Florida POWER INTERIM DRAWING
ASSIGNED TO M.A.R. 77-1-1-4
ORIGINAL DRAWING AFFECTED:
TITLE: ELEC. 3 LINE DIAG.
4160V SWGR. E.S. BUS 3A
DRAWING NO. C-207-014
INTERIM REV. NO. A
DRAWN BY: KDH
CHECKED BY:
APPROVED BY:
ISSUE DATE:

CHANGE IN PROGRESS
DUE TO
M.A.R./R.E.I. 77-2-2-2

UNIT NO. 3 855,000 KW
ELECTRICAL
THREE LINE DIAGRAM
4160V SWGR.
ENGINEERED SAFEGUARDS BUS 3A

4203 C-207-014 EC-207-014

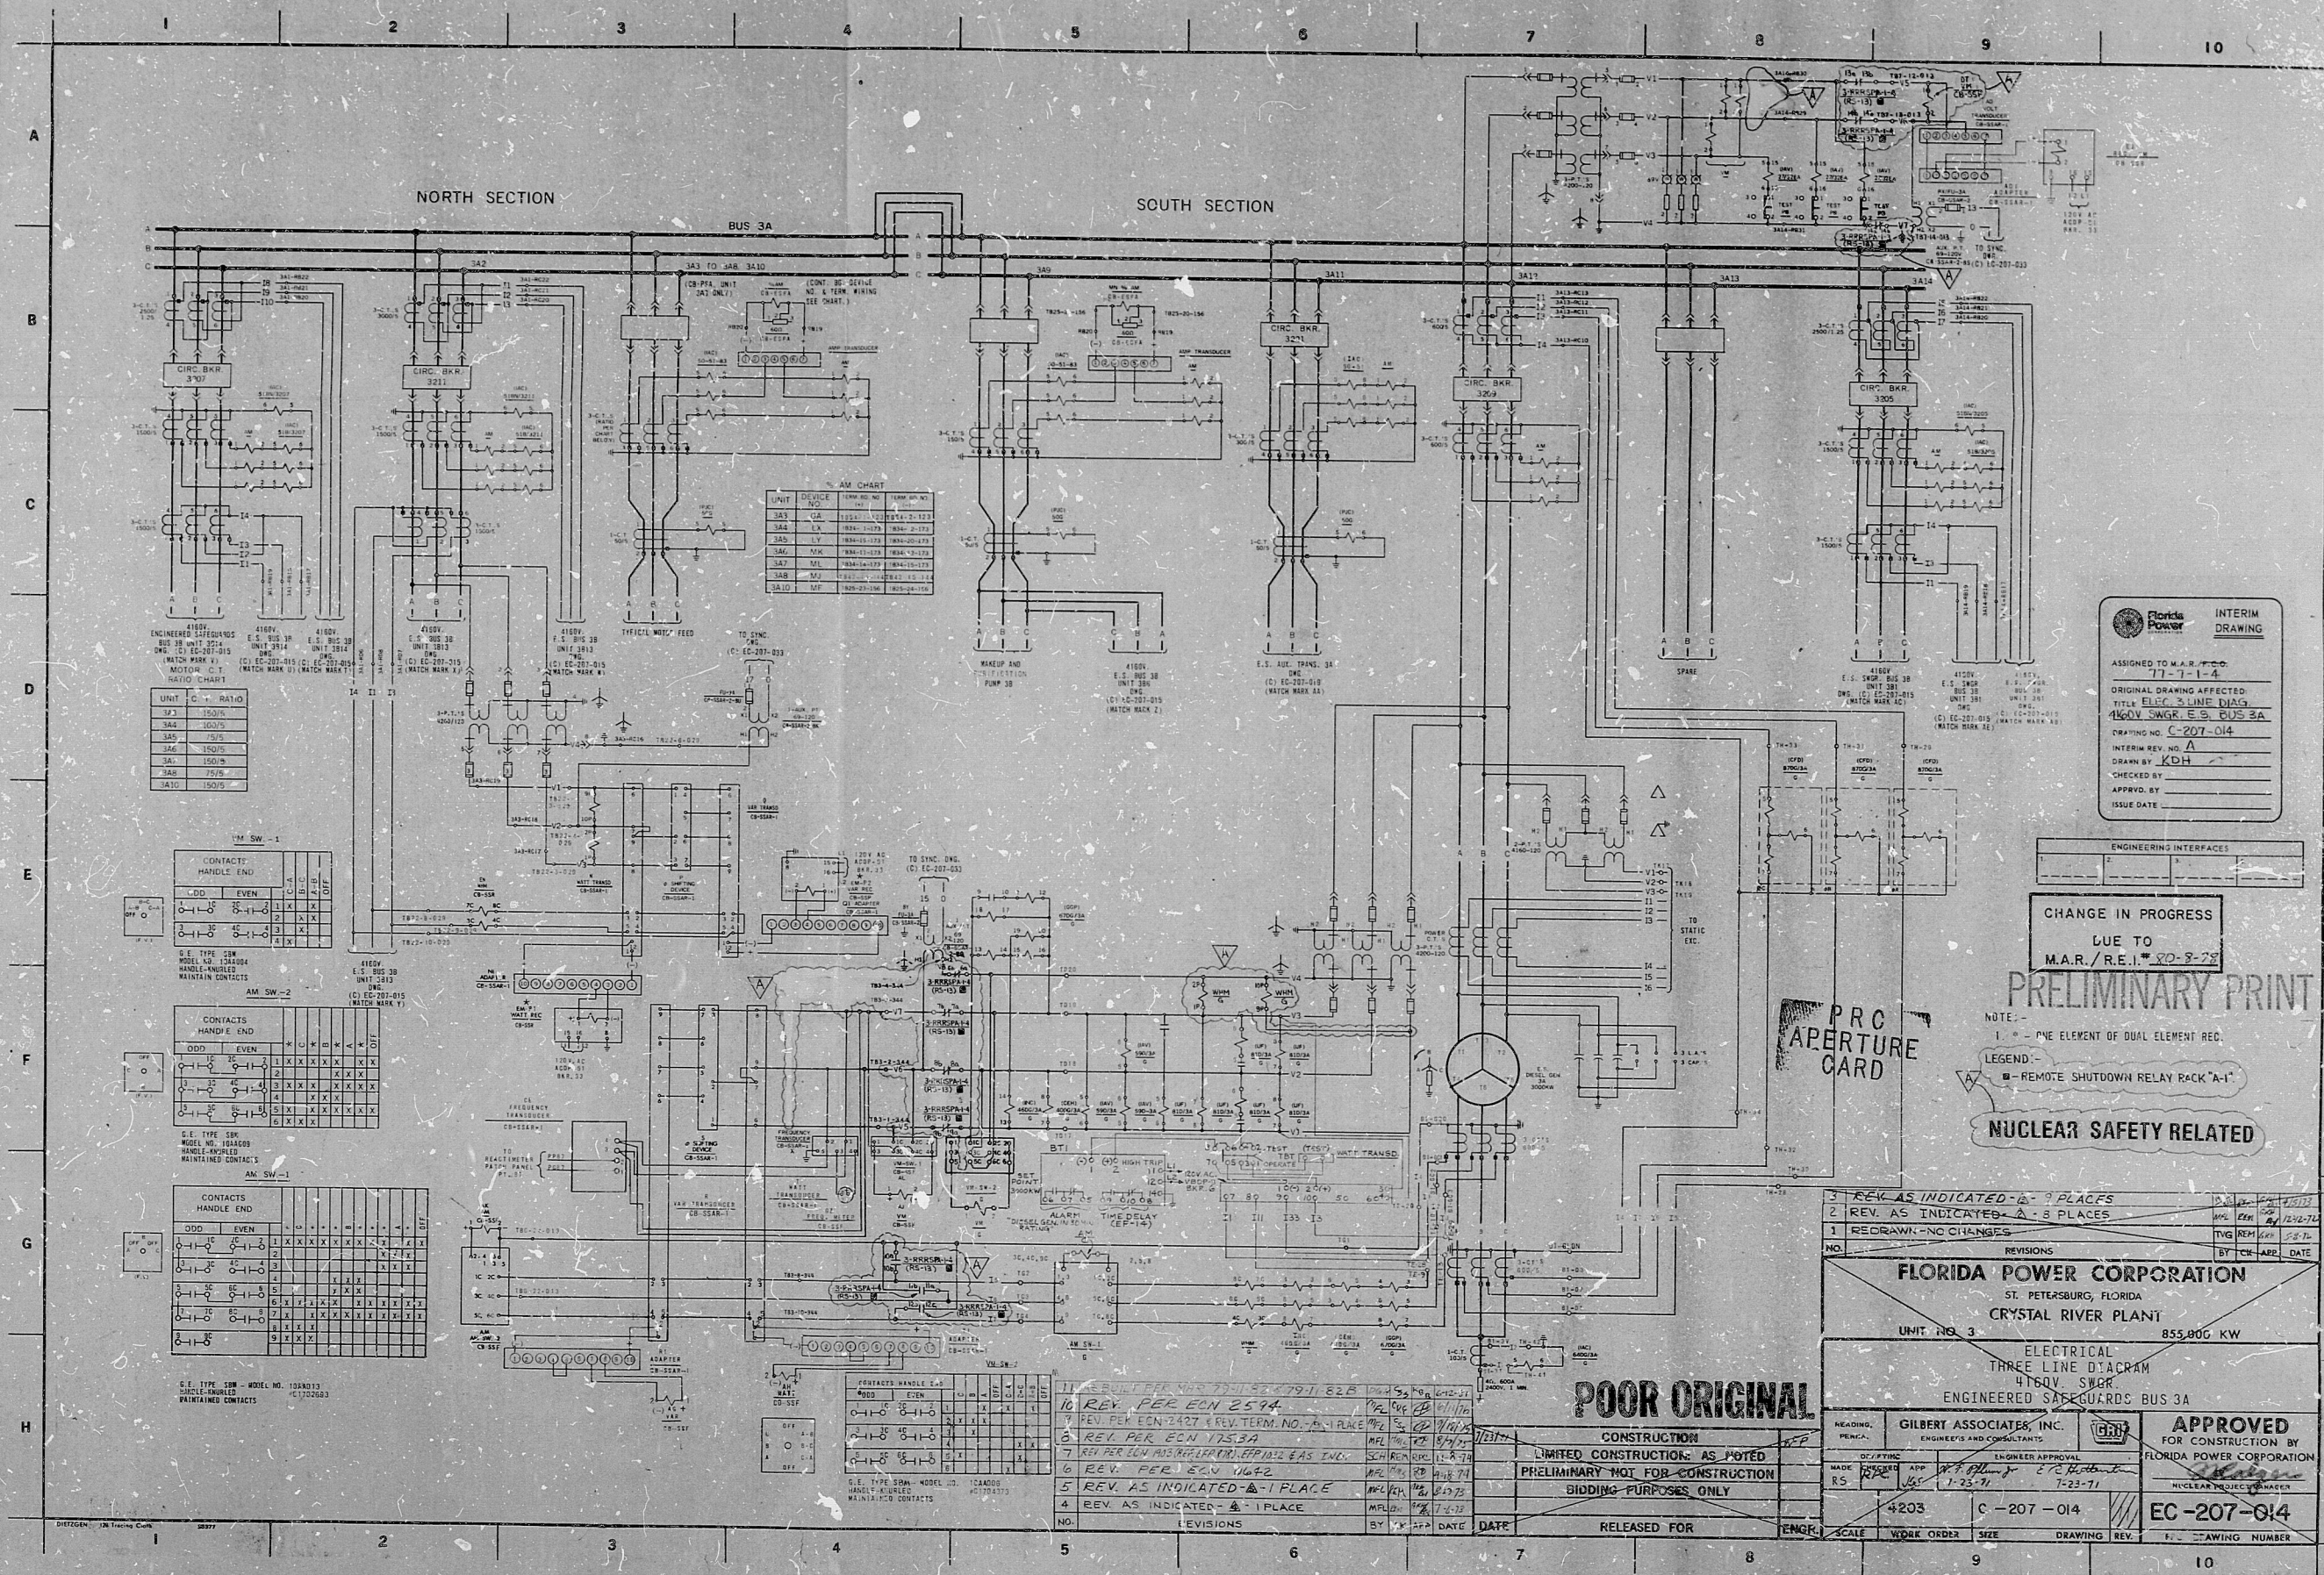
REV. AS INDICATED - 6 PLACES
2 REV. AS INDICATED - 3 PLACES
1 REDRAWN - NO CHANGES
